Application Number: F/YR13/0574/F
Major
Parish/Ward: March West
Date Received: 31 July 2013
Expiry Date: 30 October 2013
Applicant: King Partnership Homes Ltd.
Agent: Mr R Woolston, rp+g Ltd.

Proposal: Erection of 52no 2-storey dwellings comprising of 35 x 2-bed, 13 x 3-bed and 4 x 4-bed with landscaping and play area
Location: Land North of Electricity Substation, Gaul Road, March

1. EXECUTIVE SUMMARY/RECOMMENDATION

| Sheet title: | Site Plan |

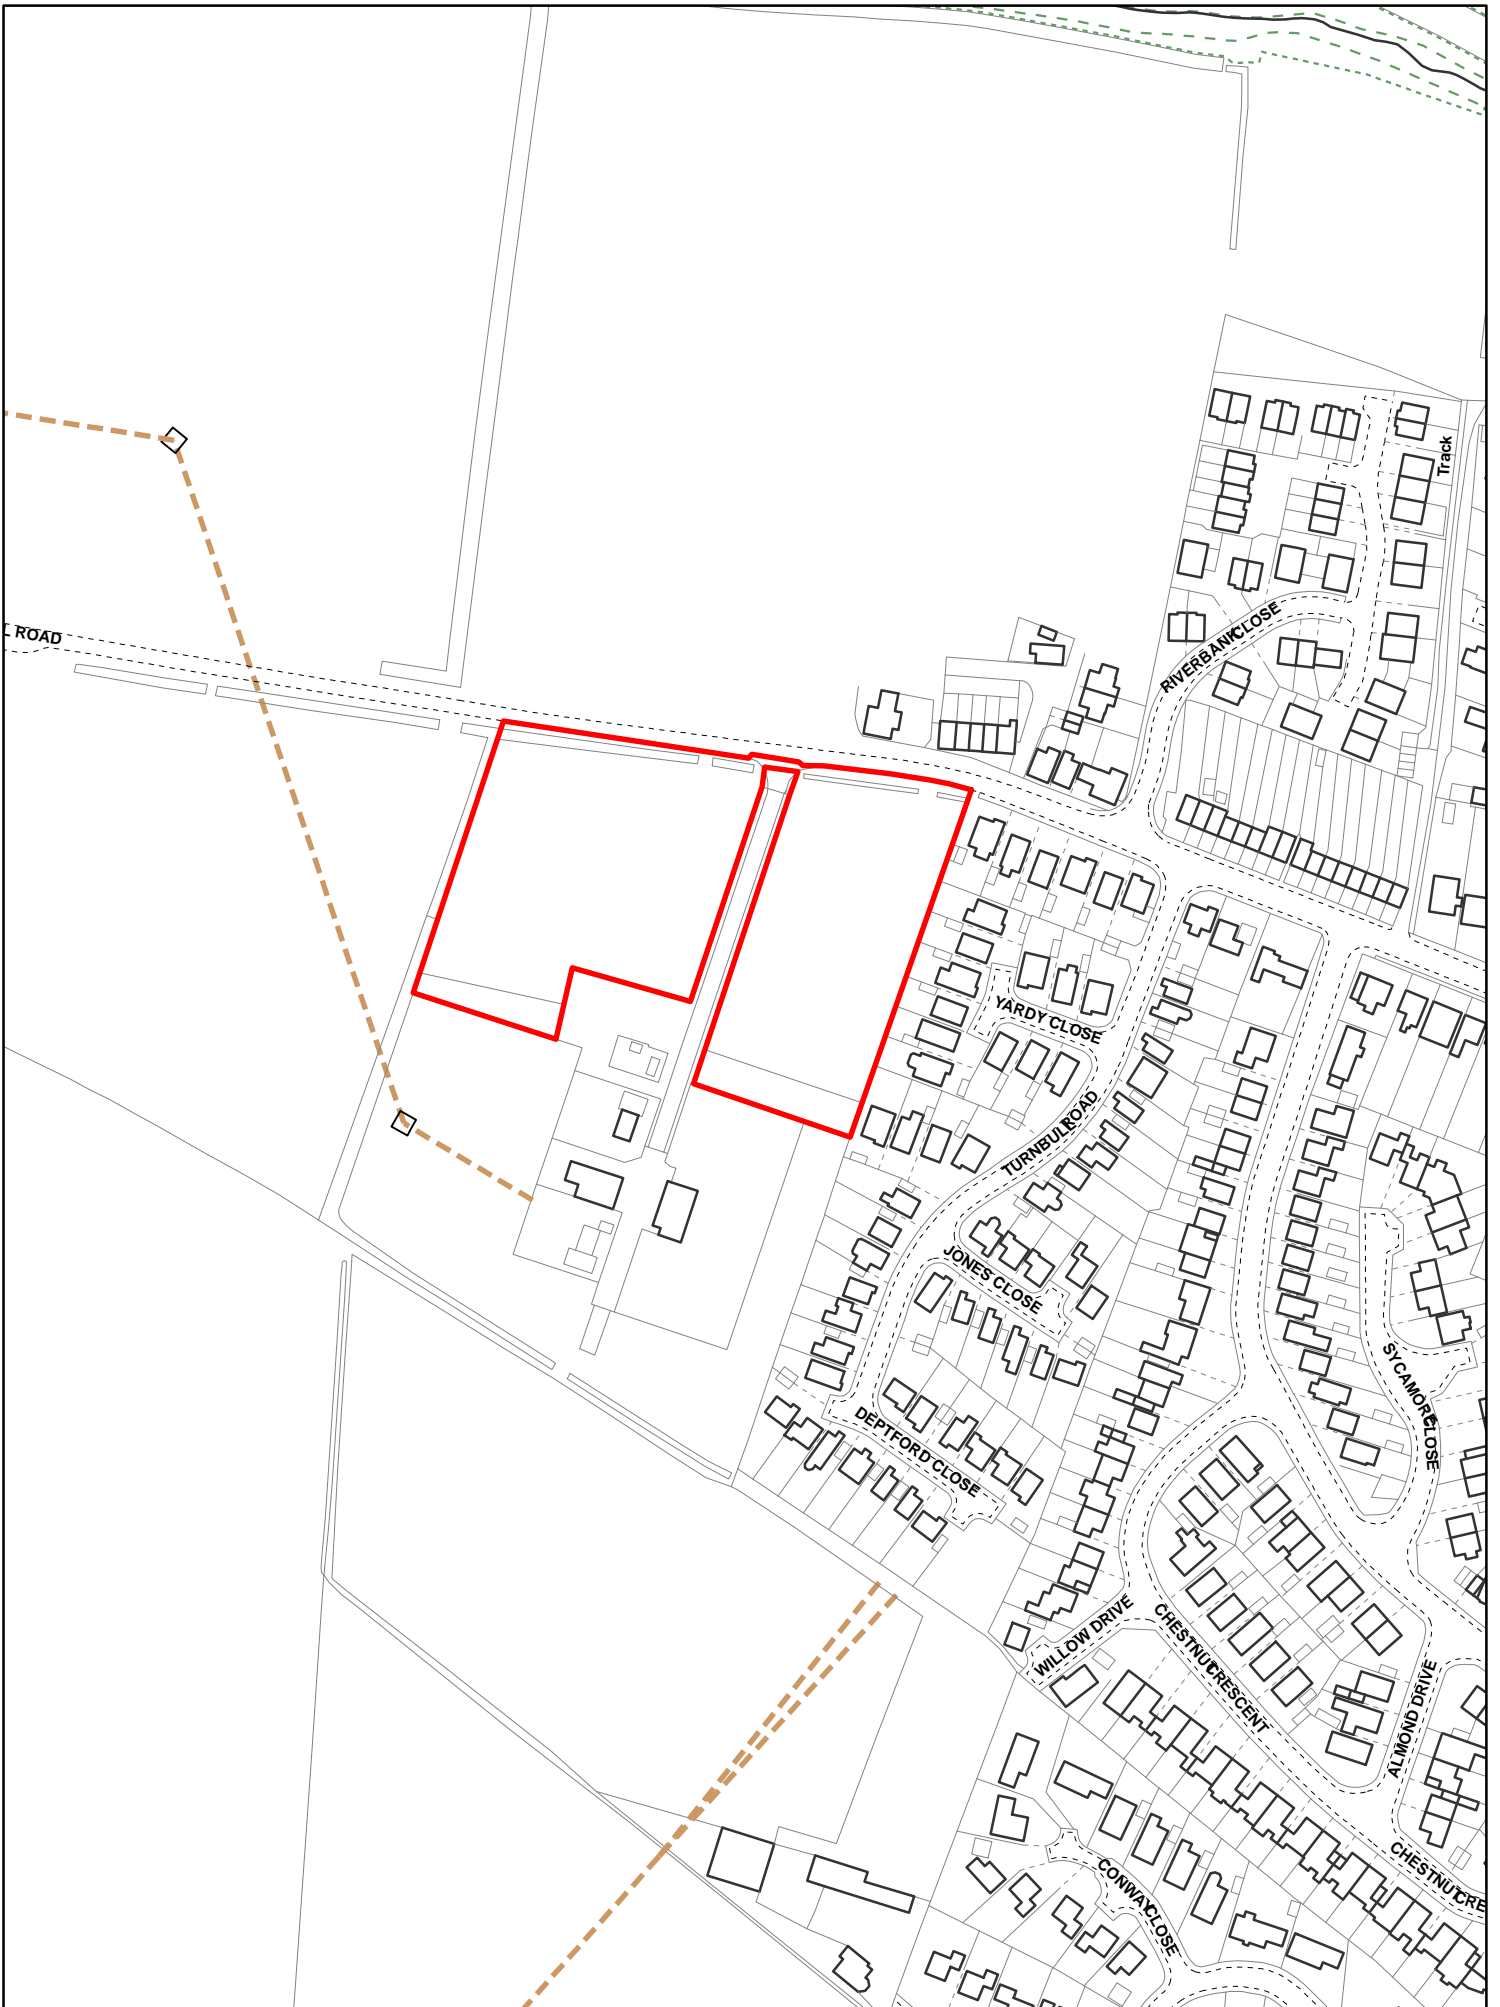
The original proposals submitted raised concerns with regard to the lack of parking, the relationship of Plot 49 and Plot 40 with adjoining bungalows to the east of the site and the provision of bin storage points for the shared drives. The scheme has now been amended to address these requirements.

The revised positions of the two plots mentioned above are now considered to be at an acceptable distance from the adjoining bungalows and are not considered to have any undue impacts in terms of overlooking or overshadowing. Elsewhere the proposed development is considered to have an acceptable relationship with the adjoining built form.

The revised site layout plan has been reviewed by the LHA and the concerns with regard to the lack of parking have been satisfactorily addressed. Whilst a plan showing all road dimensions has yet to be submitted, the site layout plan provided does scale appropriately and a condition relating to the submission of these details can be appended to the permission.

The revised site layout plan shows bin collection points along the shared driveways in positions where in certain instances vehicle to pedestrian visibility splays at the back edge of the footways would be obstructed. Ideally these collection points should be sited 2 metres clear of the access points and this element needs to be resolved either by way of an amended plan or through a condition. This aspect would be updated at Planning Committee.
